UNITED STATES PATENT AND TRADEMARK OFFICE

10/563,422

Office Action Summary	Application No.	Applicant(s)	
	10/563,422	JACOBSEN, PER	
	Examiner	Art Unit	
	Dinesh Vesra	3633

DETAILED ACTION

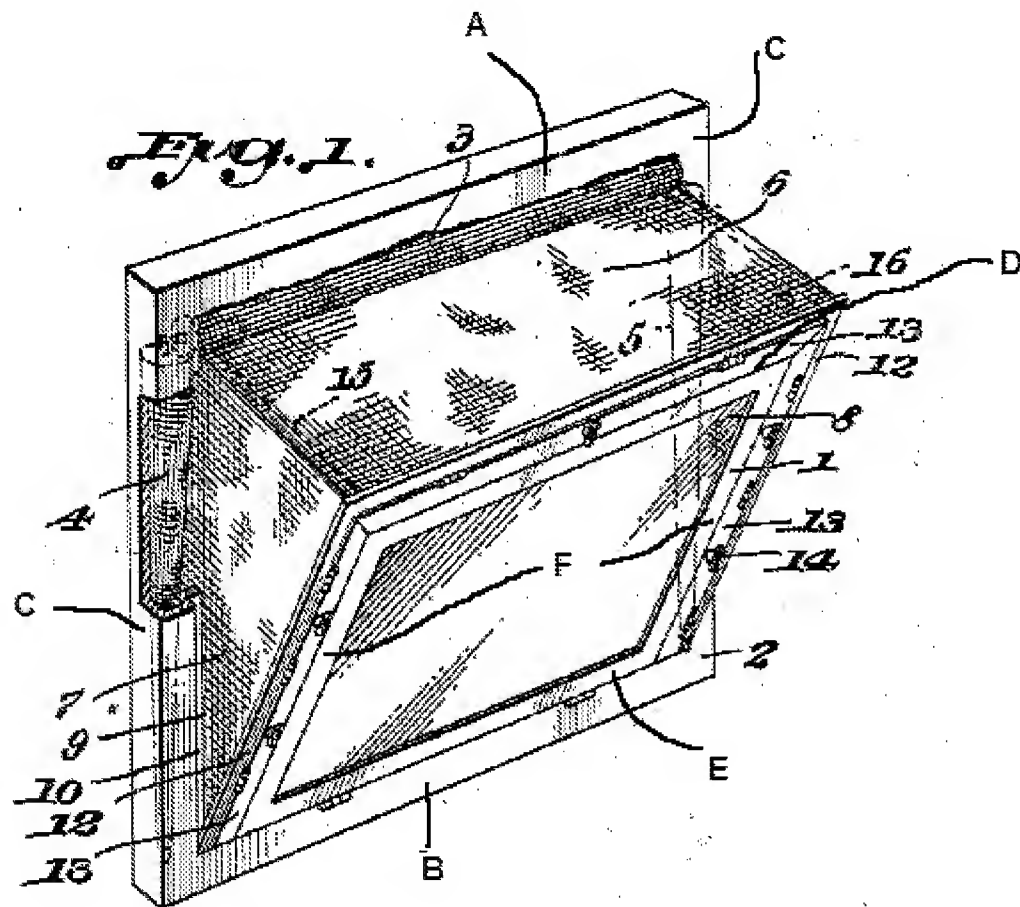
7. **Claims 18, 19 are rejected under 35 U.S.C. 102(b) as being anticipated by Persson (US Patent 2,311,413).** Persson discloses a window (see Fig. 1 below) comprising a frame (2) having a top member (A), a bottom member (B) and two side members (C) defining a frame plane; a sash (1) having a top member (D), a bottom member (E) and two side members (F) defining a sash plane; a screening arrangement (7); the sash being connected to the frame by means of at least one hinge (Column 1, lines 58-60) connection to provide a hinge axis substantially parallel with the frame top member and the sash top member, such that the sash may be moved from a closed position to a ventilating position, in which ventilating position the sash plane forms an angle within a limited angle range with the frame plane to provide at least one ventilating Aperture, said screening arrangement covering said at least one ventilating aperture at least partly in the ventilating position; said screening arrangement comprising at least one screening element (7) which in closed position of the window, is arranged in an inactive position at the interface (12 – Fig. 2) between frame and sash, and in the ventilating position spans the ventilating aperture between the frame bottom member and the sash bottom member, and/or between the frame top member (A) and the sash top member (D), and that the at least one screening element is connected with the sash or frame top or bottom member and is in releasable engagement (13) with the corresponding frame or sash member within said limited angle range, wherein said at least one screening element is provided exclusively at the top and/or bottom member of the sash and the frame (as shown in Fig. 1 below); wherein the at least one screening element of the screening arrangement is adapted to be moved automatically from an

inactive position corresponding to the closed position of the window to an active position corresponding to the ventilating position, and from the active position to the inactive position when the window is brought from its ventilating position to its closed position (Column 1, lines 16 - 20); wherein the screening arrangement further comprises interface screening means arranged at the interface between the screening element and the sash side members (F).
